May 19, 2008  
L-08-070

Beaver Valley Power Station, Unit No. 1  
Docket No. 50-334, License No. DPR-66  
Impractical American Society of Mechanical Engineers Code Section XI  
Weld Examination Requirement (Request Nos. 1-TYP-3-RV-WELDS,  
1-TYP-3-RH-E-1-2, and 1-TYP-3-SI-TK-2-1)

ATTACHMENT 1  
L-08-070  
10 CFR 50.55a Request Number 1-TYP-3-RV-WELDS, Revision 0  
Page 1 of 4

ATTACHMENT 2  
L-08-070  
10 CFR 50.55a Request Number 1-TYP-3-RH-E-1-2, Revision 0  
Page 1 of 4

**REACTOR VESSEL (RC-R-1)**

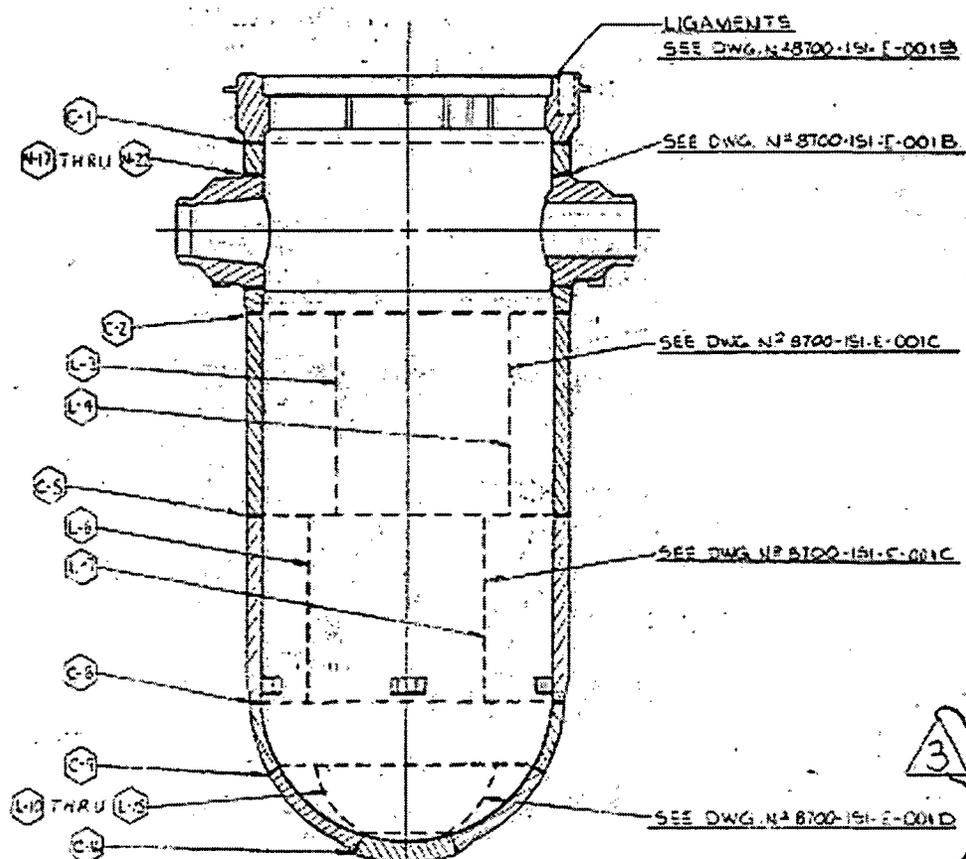
The 100 percent examination volume requirement for the affected welds has been determined to be impractical to obtain during the third ten-year inservice inspection interval due to component geometry in the case of weld C-1, and due to physical interference by the four radial support lugs in the case of weld C-8. Welds C-1 and C-8 are shown in the drawing provided on page 4. Examination limitations experienced are described in the paragraphs below.

The automated examination of the flange to shell weld C-1 was limited to 63.93 percent of the required volume due to the configuration of the flange. The proximity of the weld to the flange inside diameter taper transition limits scanning in both perpendicular and parallel directions to the weld below the transition. Additionally, four keyways and eight irradiation specimen slots limit scanning in the direction perpendicular to the weld from the area of the inside diameter flange face. Scanning was conducted between and below the obstructing keyways and between the irradiation specimen slots with the scan boundaries maximized by visually assisted positioning of the exam head so that scan starts and stops were as close to the keyways and irradiation specimen slots as possible. Extra transducers were also added to the exam sled and positioned in the fixture to maximize coverage. Two rotations of the examination head for both perpendicular and parallel scans were employed on the portions of the weld below the inside diameter taper transition. The extra rotations maximized the coverage by putting the extra dual element transducer in the proper orientation for additional near surface coverage for the perpendicular scans and transducers as near to the transition as possible for the parallel scans.

The automated examination of the lower head to shell weld (C-8) was limited to 80 percent of the required volume. The coverage limitation was due to the proximity of four core support lugs. Scanning was conducted between and below the obstructing lugs with the scan boundaries maximized by visually assisted positioning of the exam head so that scan starts and stops were as close to the support lugs as tool configuration would allow.

As an alternative to the 100 percent examination volume requirement, examination of reactor vessel circumferential welds RC-R-1-C-1 and RC-R-1-C-8 to the maximum extent practicable, which includes 100 percent of the weld circumference from the flange face (per ASME Code Section XI, only 50 percent of the weld was required to be examined from the flange face), is proposed. These examinations are supplemented by the visual examination performed on the interior of the vessel. The four support lugs and the flange to shell weld are included in this examination.

Ultrasonic test examinations coupled with the visual examination of the support lugs and the surrounding areas, and the visual examination of the interior surface of the flange to shell weld, provide adequate assurance of weld integrity.

RESIDUAL HEAT EXCHANGERS  
(RH-E-1A + 1B)

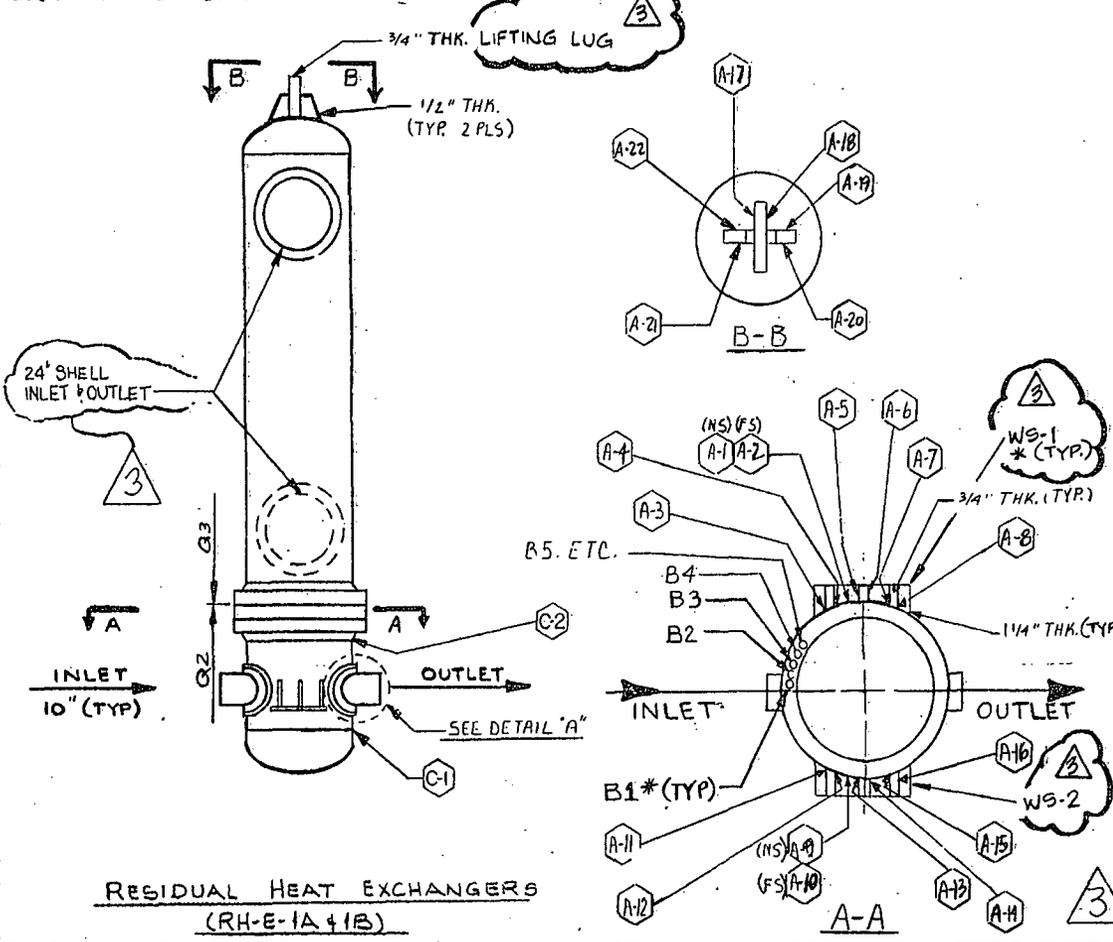
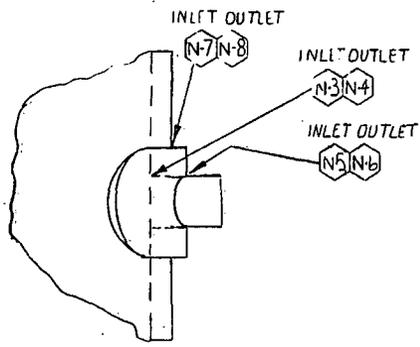
The 100 percent examination has been determined to be impractical because examination of weld C-1 during the third ten-year inspection interval was limited by curvature of the lower head and weld crown. Examination of welds C-1 and C-2 was limited by physical interference from welded support plates and inlet and outlet nozzle external reinforcing saddles. The 45 degree axial scans were supplemented with 60

Approximately 86 percent of weld RH-E-1A-C-1 and 71 percent of weld RH-E-1A-C-2 were examined in the third ten-year inspection interval. Since input values used to calculate coverage percentages are not precise, the calculated percentages differ between inspection intervals, even though the actual extent of examination does not differ and is the maximum extent practical. The examination limitations resulting from the curvature of the lower head and weld crown, welded support plates, and inlet and outlet nozzle external reinforcing saddles described above are common to both heat exchangers RH-E-1A and RH-E-1B. Relief is being requested because the actual coverage experienced during the third interval indicates that 100 percent coverage during the fourth interval would be impractical.

As an alternative to the essentially 100 percent examination volume requirement specified in Table IWC-2500-1, Examination Category C-A, examination of welds RH-E-1A-C-1 and RH-E-1A-C-2 to the maximum extent practical using a 45 degree axial angle, supplemented with a 60 degree axial angle, is proposed.

The heat exchanger shell adjacent to welds C-1 and C-2 is 0.875-inch thick, SA-240, TP304 material. Welds C-1 and C-2 receive VT-2 examinations in accordance with Category C-H, which would detect through-wall leakage. Complete VT-2 examination along with volumetric examination to the maximum extent practical would ensure continued reliability of these welds.
